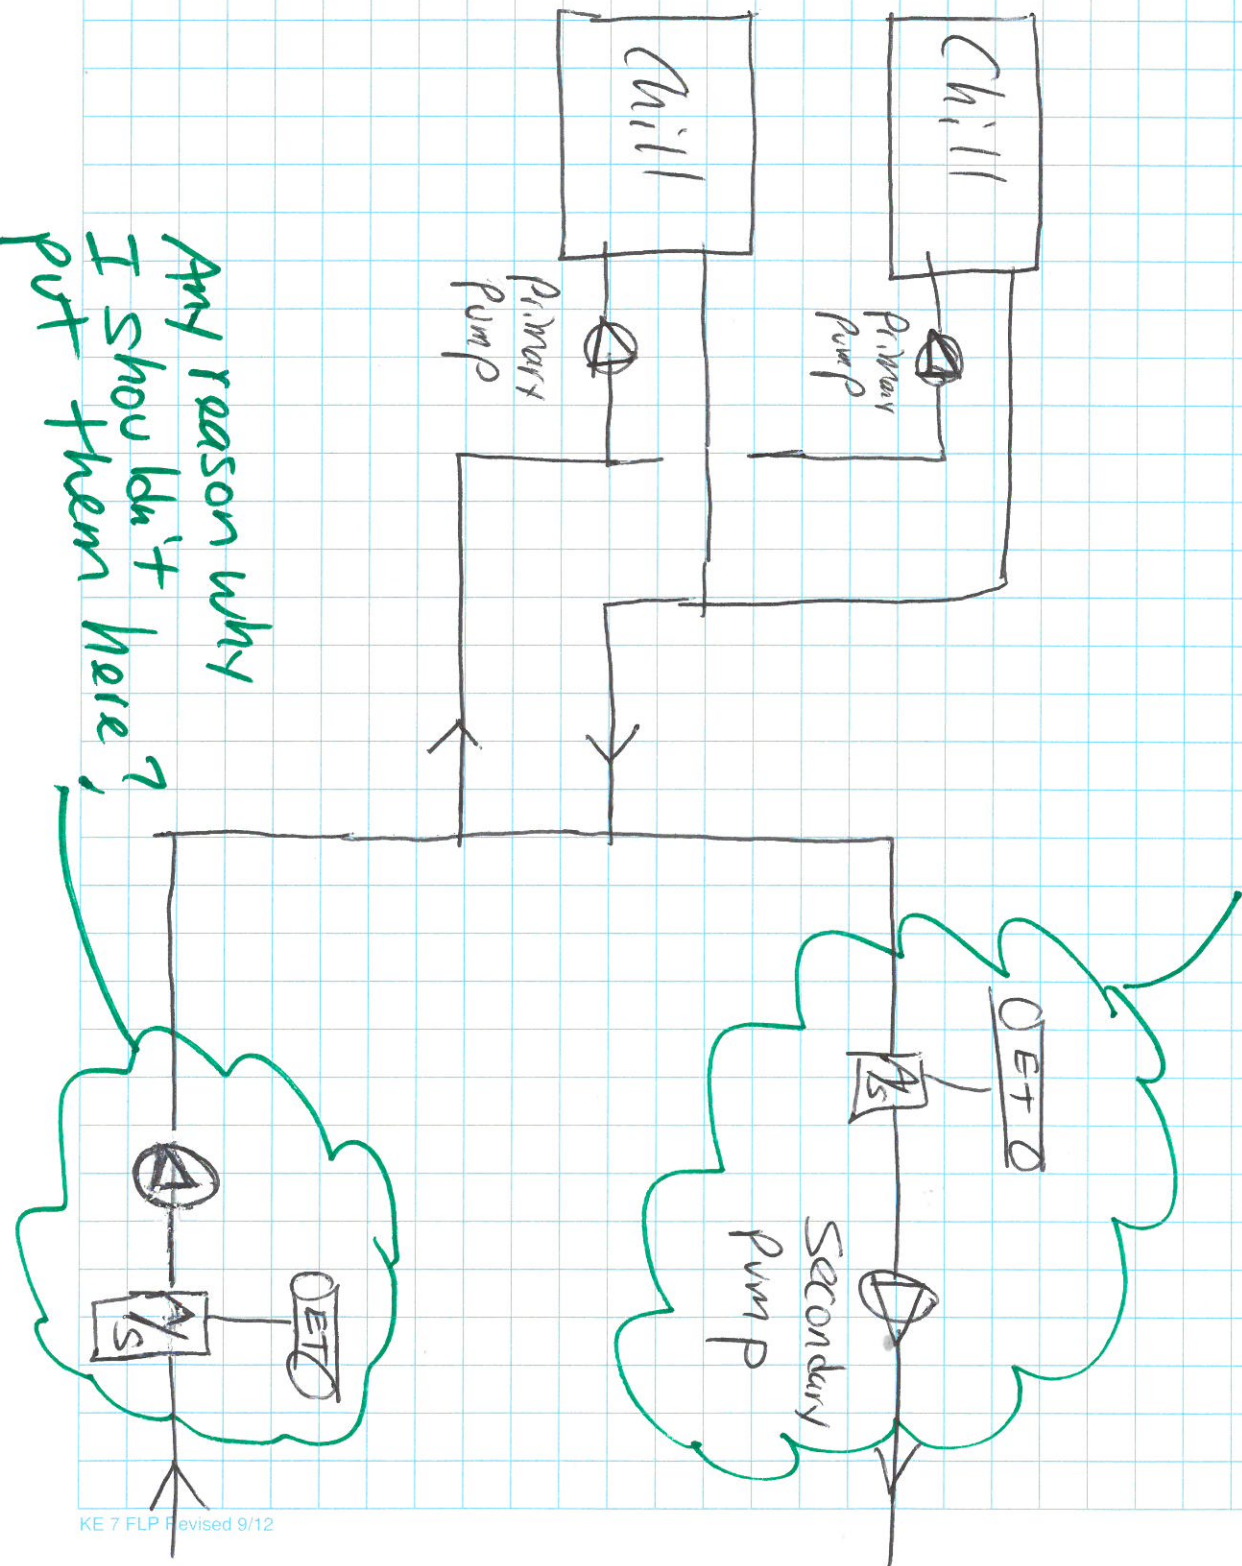
This is where I normally put Secondary Pumps.

Any reason why I shouldn't put them here?
